n re Patent Application of)
Seong-Hwoon Kim et al) Group Art Unit: 2817
Application No.: 10/091,398) Examiner: Benny T. Lee
Filed: March 7, 2002) Confirmation No.: 8639
For: IN-LINE PHASE SHIFTER)
)
•	,)

AMENDMENT

In re Patent Application of	
Seong-Hwoon KIM et al. Should be: Application No. 09/682,179 10/091, 398	Group Art Unit: 2817 Examiner: Benny T. Lee
Filed: March 7, 2002	Confirmation No.: 8639
For: INLINE PHASE SHIFTER)

Fig. 1

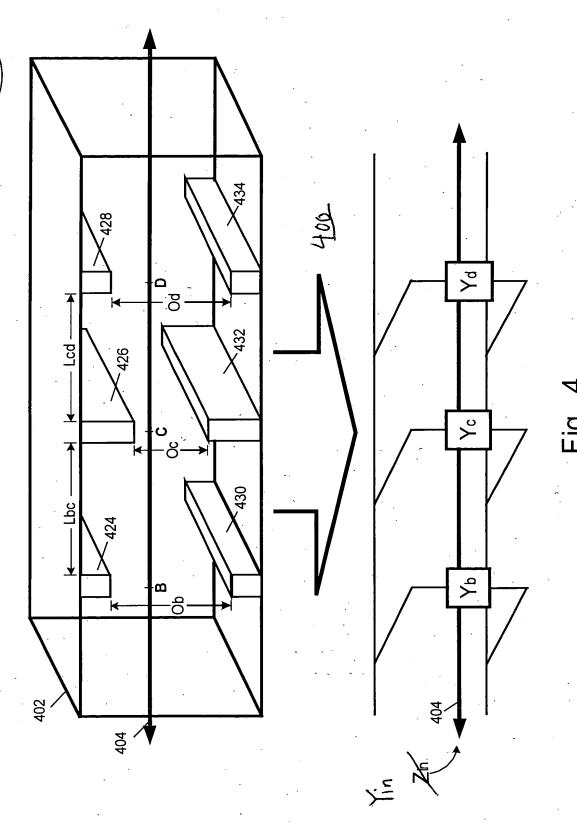
The attached sheets of drawings includes changes to Figs. 1 and 4. These sheets,

which include Fig. 1 and Fig. 4, replace the original sheets including Fig. 1 and Fig 4. In Fig.

1, reference item 126 under reference item 110 has been changed to --128-- to correct a

typographical error. (See paragraph [0022].) In Fig. 4, the reference character --400-- has

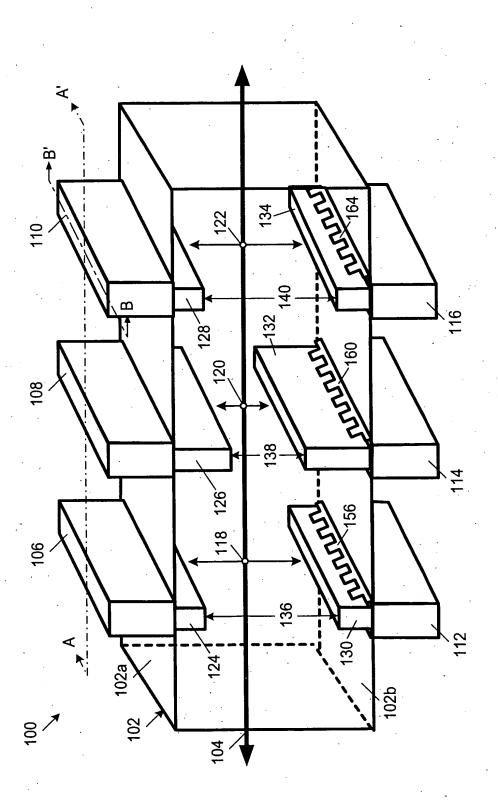
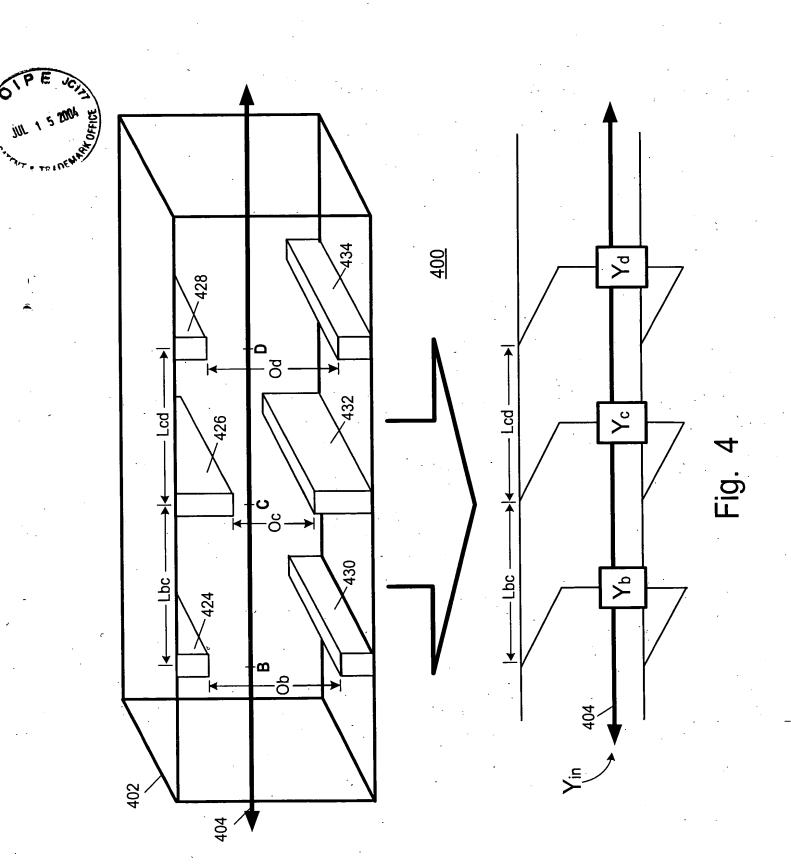
been added, as required by the Examiner on page 3 of the Office Action and described in

paragraph [0022] of the Office Action. Also in Fig. 4, "Zin" has been replaced by "Yin"

because the figure shows admittance along the waveguide path 404, as described in paragraph

[0025] of the specification.

The Office Action includes an objection to the drawings because Fig. 4 does not show reference labels "400," "Y" and "L." In response, Applicants submit herewith proposed drawing change to Fig. 4 that includes the reference labels "400" and "Yin." As noted above,

Applicants' proposed changes to Fig. 4 include replacing "Zin" with "Yin" and have amended the reference "Y" to "Yin" in the specification because the original specification describes Fig. 4 as showing admittance along the waveguide path 404. Applicants have removed the reference to "L" in the specification because it is believed that the description in paragraph [0025] of separations between openings refers to the exemplary separations "Lbc" and "Lcd" would render redundant such inclusion of an additional label "L."
